# Service Information

Model Nakamichi 500  
Serial No. Up to 370140

Subject MHX Motor Ass'y and MHX Governor P.C.B. Ass'y No. NR-0006 (1/13)  
(B) Modification Procedures for Previous Models Date 9 August 1976

Fig.1

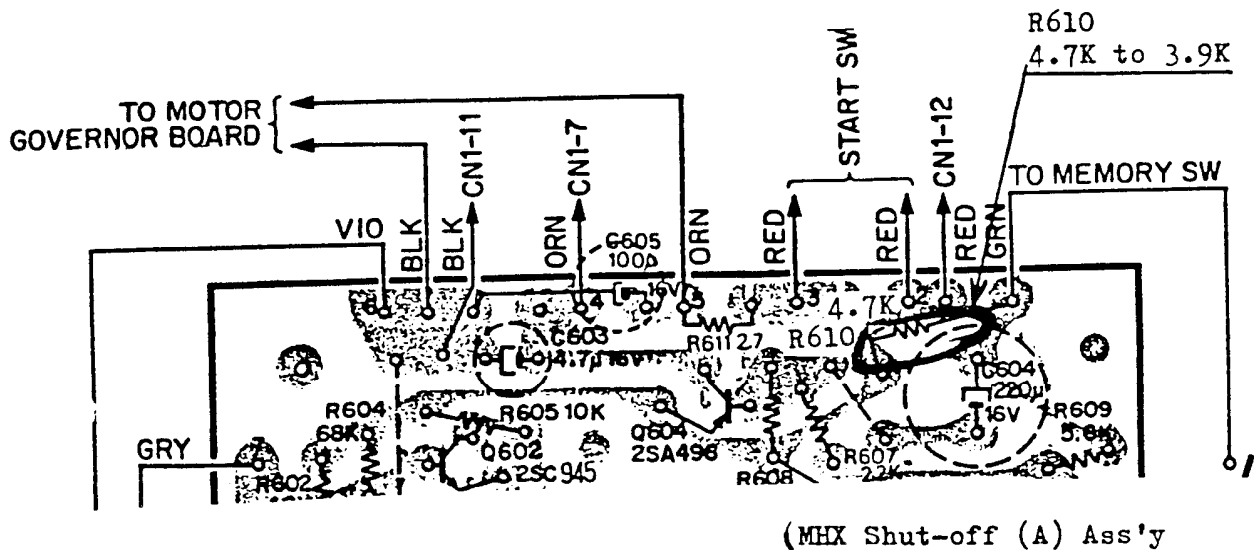
a. MHX Shut-off Ass'y:

Remove resistor R610 4.7K and replace with 3.9K.

Modification of resistor R610 (on the MHX shut-off (A) ass'y) from 4.7K to 3.9K is recommended to increase the margin for erroneous shut-off operation while in play mode.

Fig.2

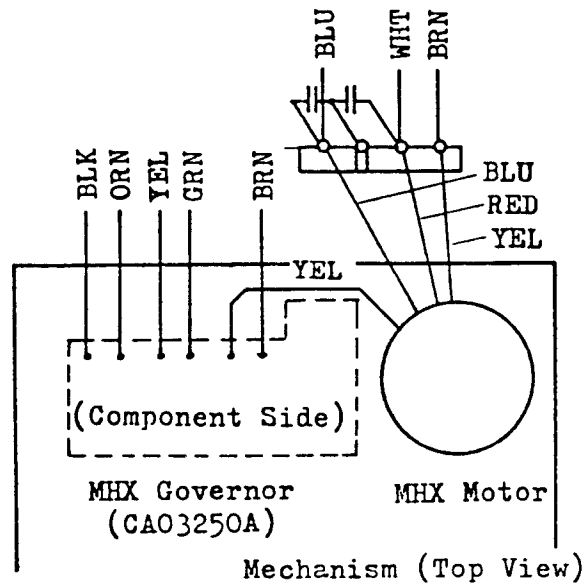
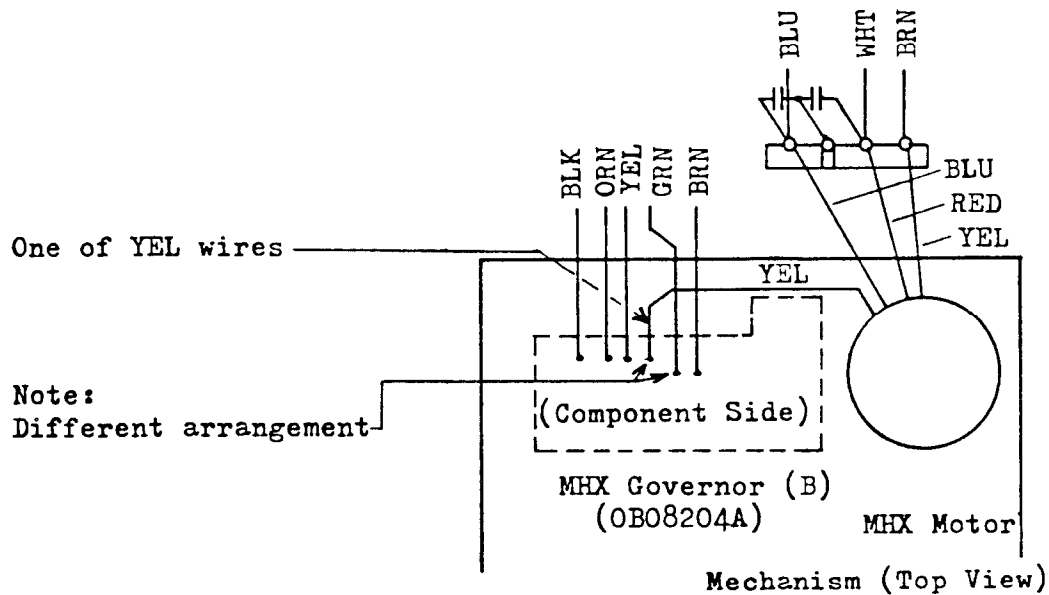
b. Motor Ass'y and Governor Ass'y:

Remove previous motor ass'y and/or governor ass'y, and replace with new motor and/or governor ass'y.

Previous Type

Note:  
Different arrangement

New Type

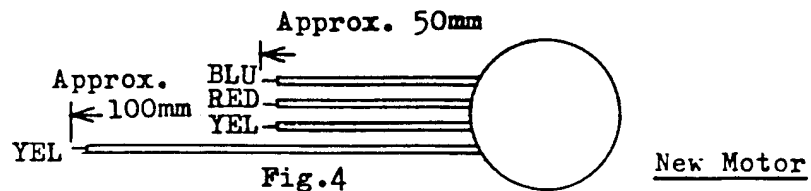
Prior to replacement of motor ass'y, shorten the signal wires as shown in Fig.4.

Fig.5

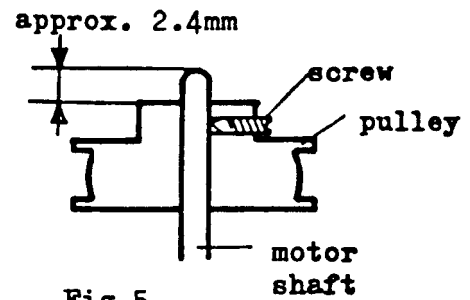
- (3) After replacement of motor ass'y, adjust the pulley position of new motor as shown in Fig.5 then check the position of driving belt to insure the following:

- (a) Set a driving belt through Flywheel, Idler Pulley, Belt Guide and Motor Pulley.

- (b) Turn the motor back and forth by hand and check to insure whether the drive belt is travelling along the correct position i.e. the centerpart of the idler pulley is free from contact with the belt guide.

Fig.6

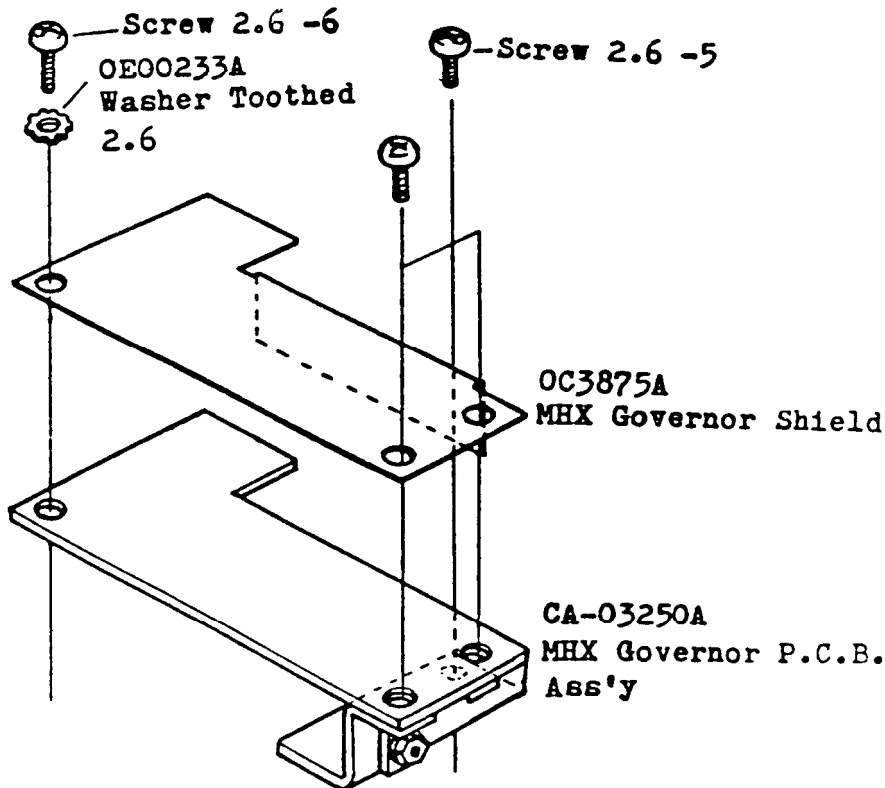
- (3) Assemble the MHX Governor Shield referring to Fig.6.

Fig.7

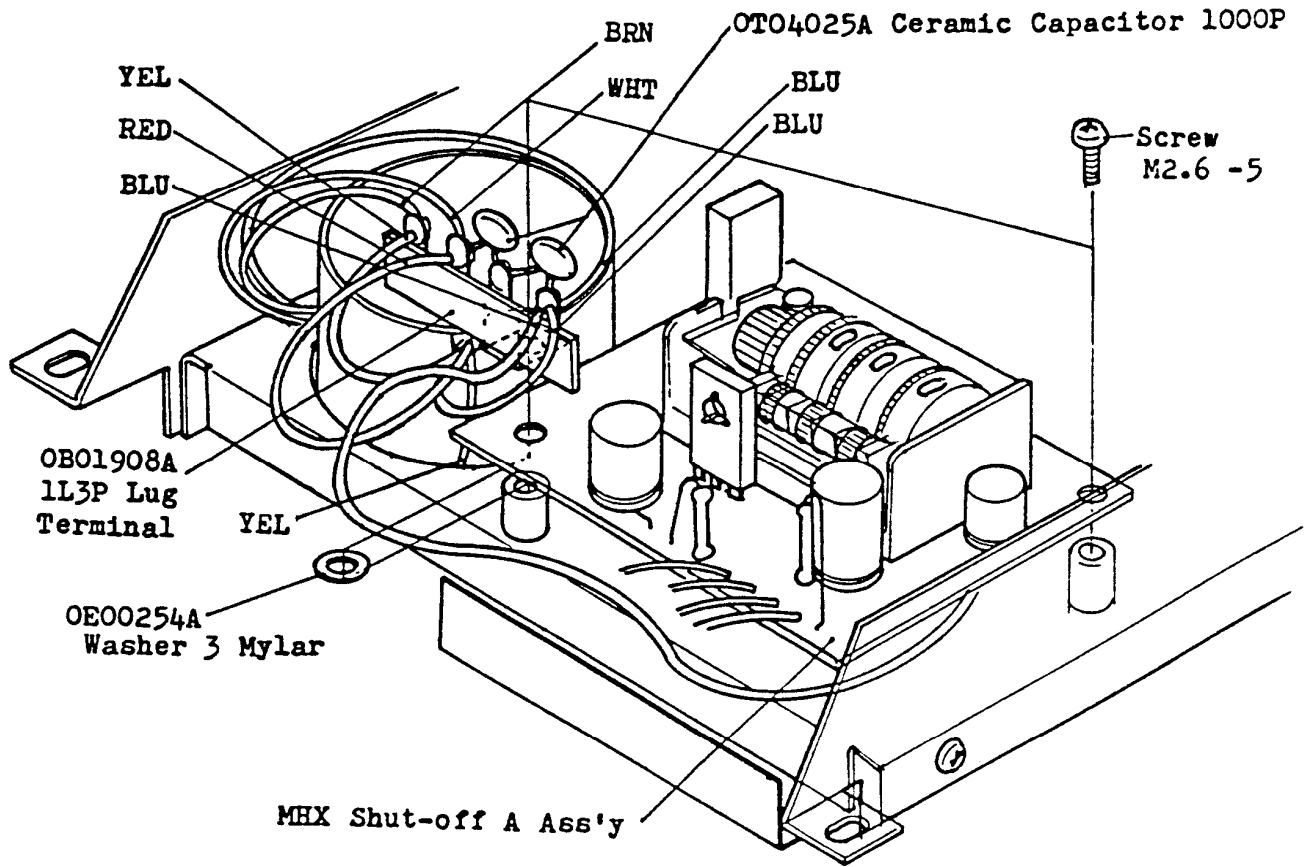
Connect the motor signal wires referring to Fig.7, 8 and 10.

Refer to Fig.6, 7 and 8.

- (1) Remove the previous motor governor ass'y and replace with new one.
- (2) Unsolder signal wires from previous type governor ass'y and resolder to the new one, and also solder one of the optional YEL wires of motor ass'y.

(2) Assemble the lug terminal and ceramic capacitors, referring to Fig.7 and 10.

Fig.8

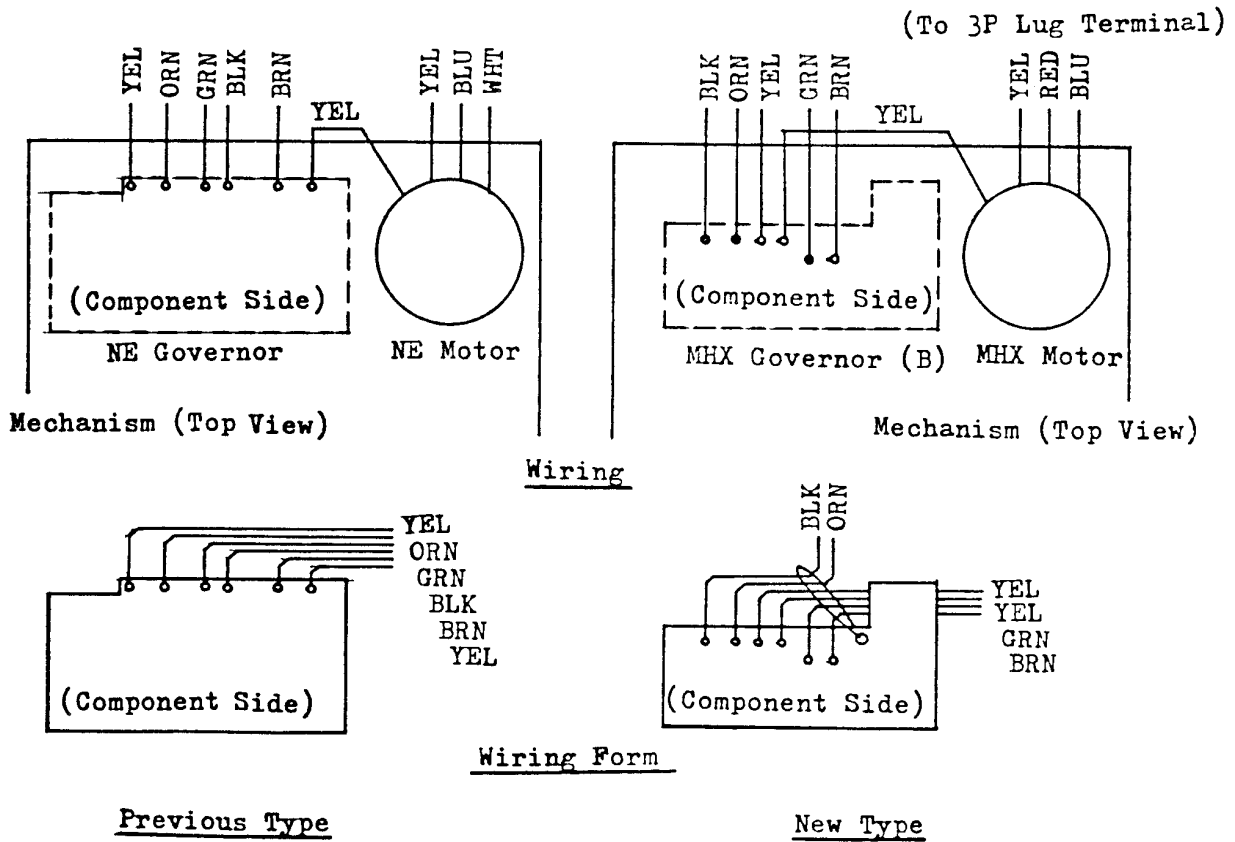
Note: Shorten the BLK and ORN wires connected to the auto shut-off P.C.B. ass'y and change the wiring route as illustrated in Fig.8 Wiring Form.

Fig.9

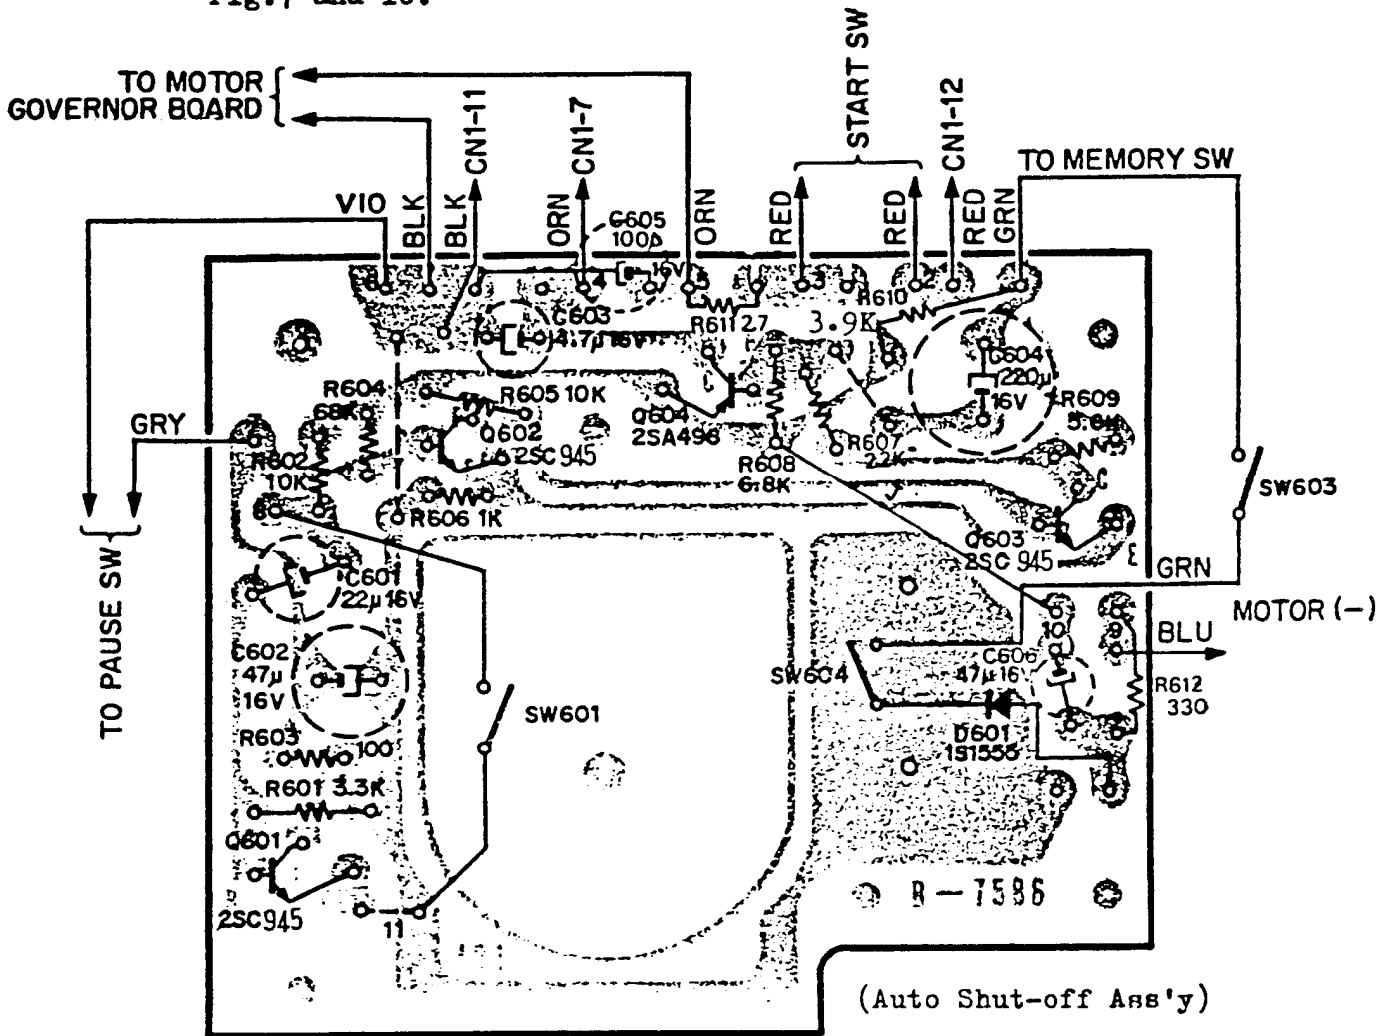
(1) Unsolder signal wires from previous shut-off ass'y and resolder to the new one (wiring arrangement is the same).

Refer to Fig.9.

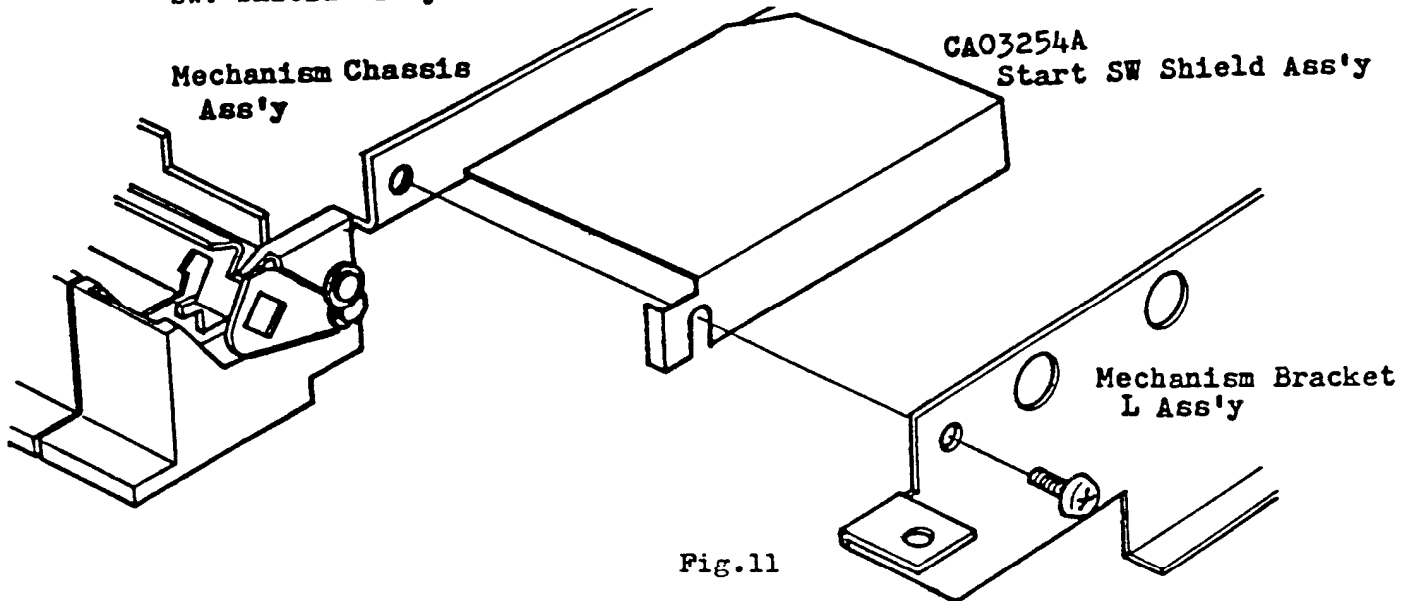
See Fig.11. Loosen mechanism bracket L ass'y and insert the start sw. shield ass'y between mechanism chassis and mechanism bracket.

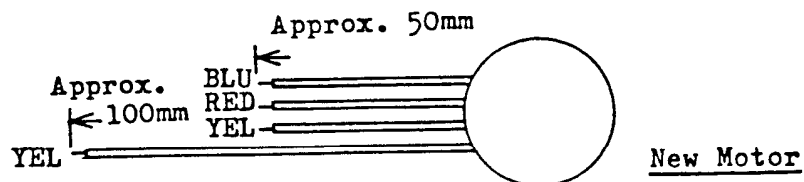
Prior to replacement of motor ass'y, shorten the signal wires as shown in Fig.13.

Fig.14

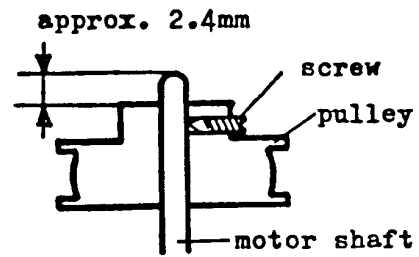
(3) After replacement of motor ass'y, adjust the pulley position of new motor as shown in Fig.14 then check the position of driving belt to insure the following:

- (a) Set a driving belt through Flywheel, Idler Pulley, Belt Guide and Motor Pulley.
- (b) Turn the motor back and forth by hand and check to insure whether the drive belt is travelling along the correct position i.e. the centerpart of the idler pulley is free from contact with the belt guide.

Fig.15

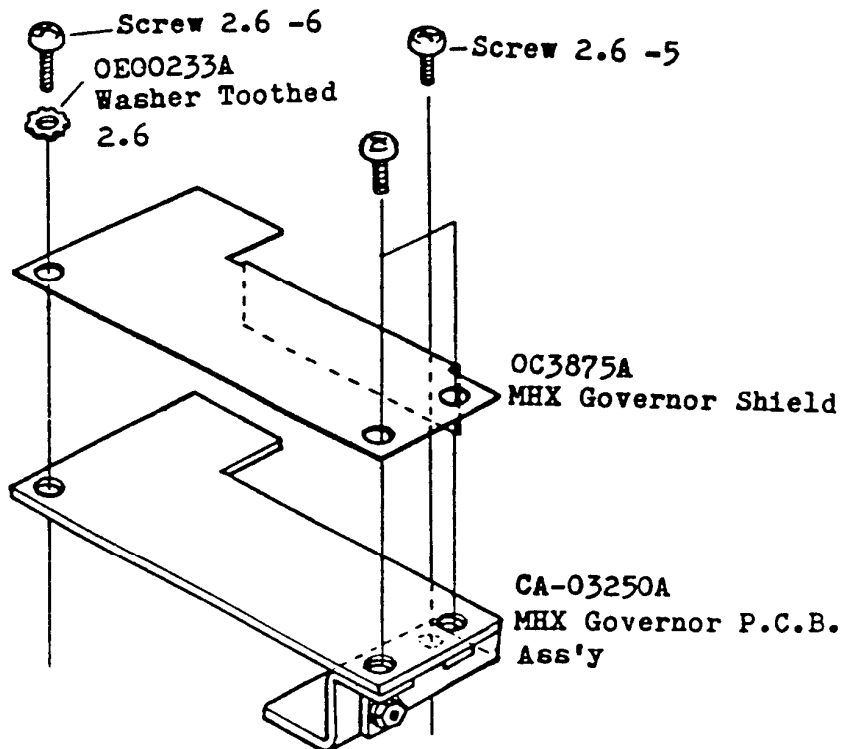
- (3) Assemble the MHX Governor Shield referring to Fig.15.

Fig.16

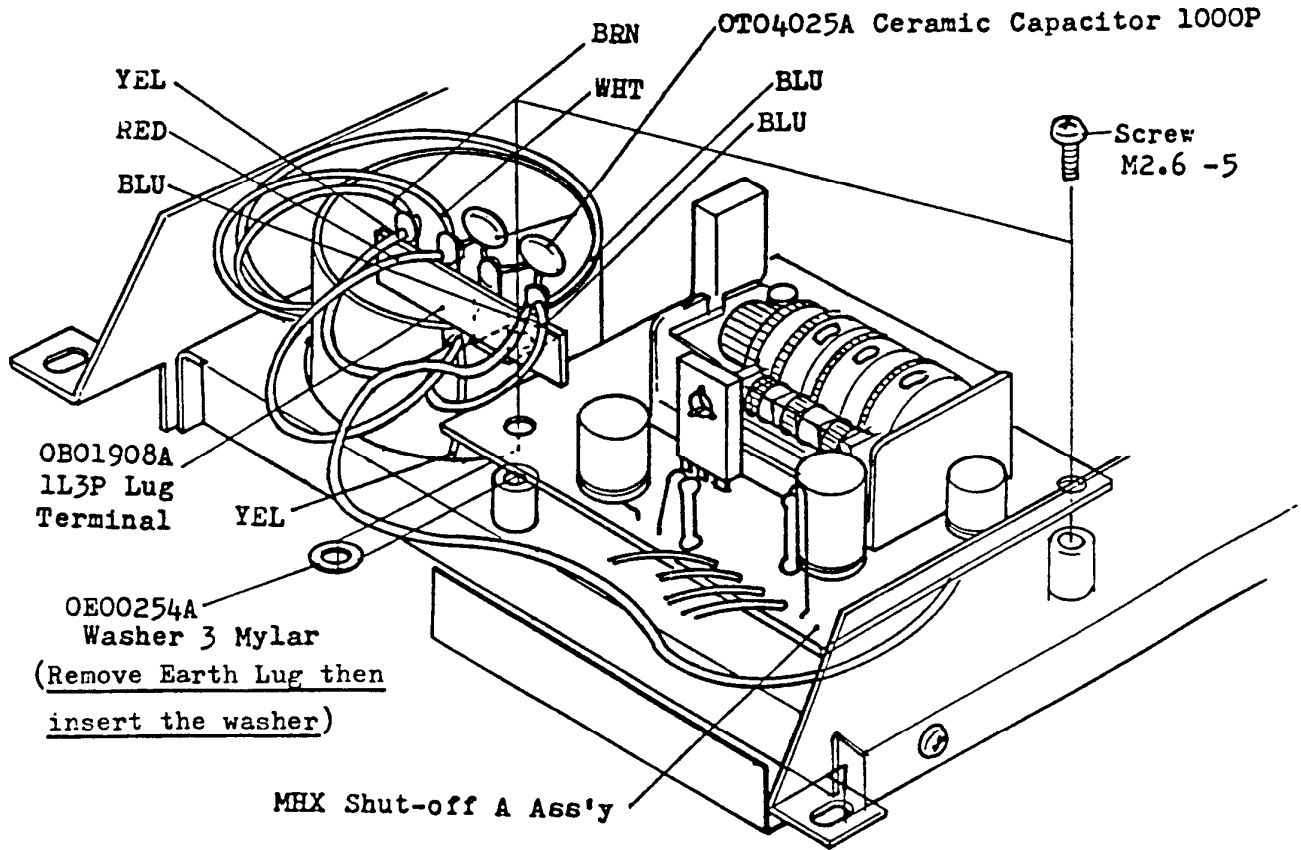
Connect the motor signal wires referring to Fig.16, 17 and 19.

Refer to Fig.15, 16 and 17.

- (1) Unsolder signal wires from previous shut-off ass'y, and resolder to the new one (wiring arrangement is the same). Refer to Fig.18.
- (2) Remove earth-lug from the auto shut-off ass'y then insert the mylar washer between auto shut-off ass'y and chassis as illustrated in Fig.16.
- (3) Assemble the lug terminal and ceramic capacitors, referring to Fig.16 and 17.

Fig.17

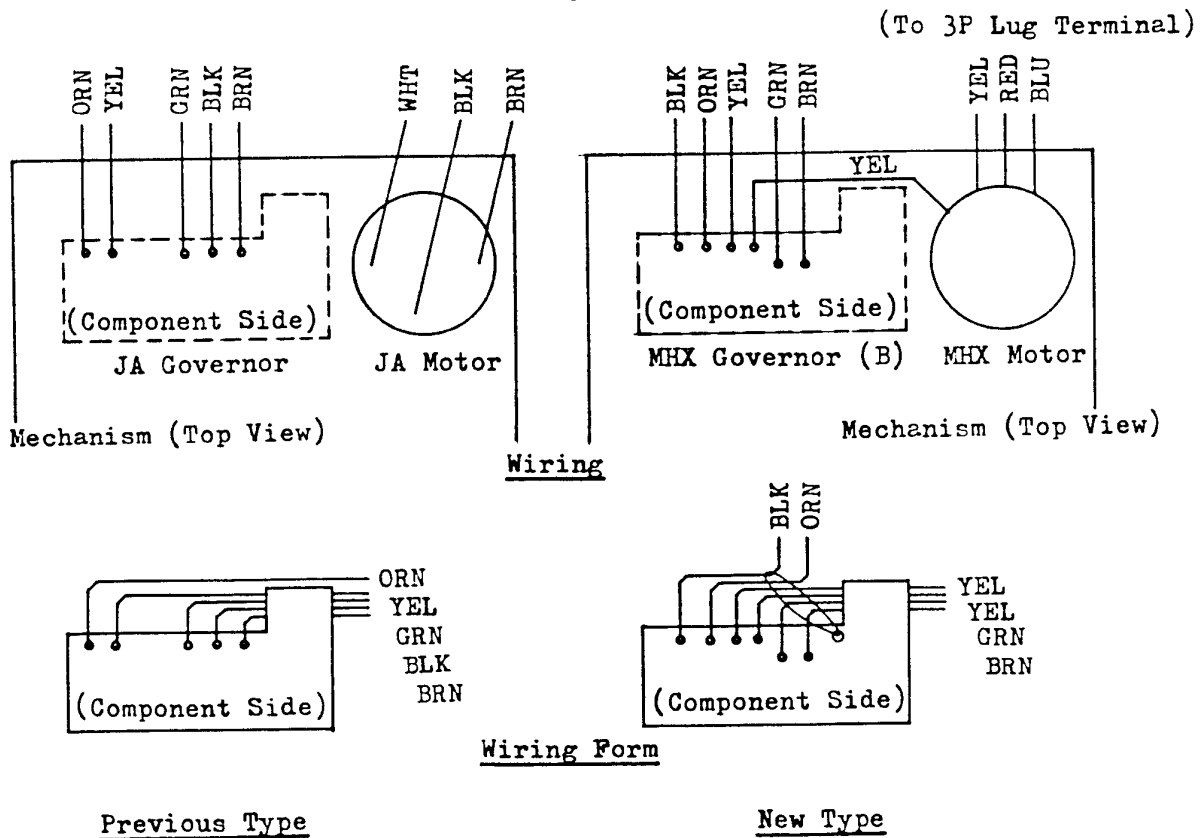
Note: Shorten the BLK and ORN wires connected to the auto shut-off P.C.B. ass'y and change the wiring route as illustrated in Fig. 17 wiring form.
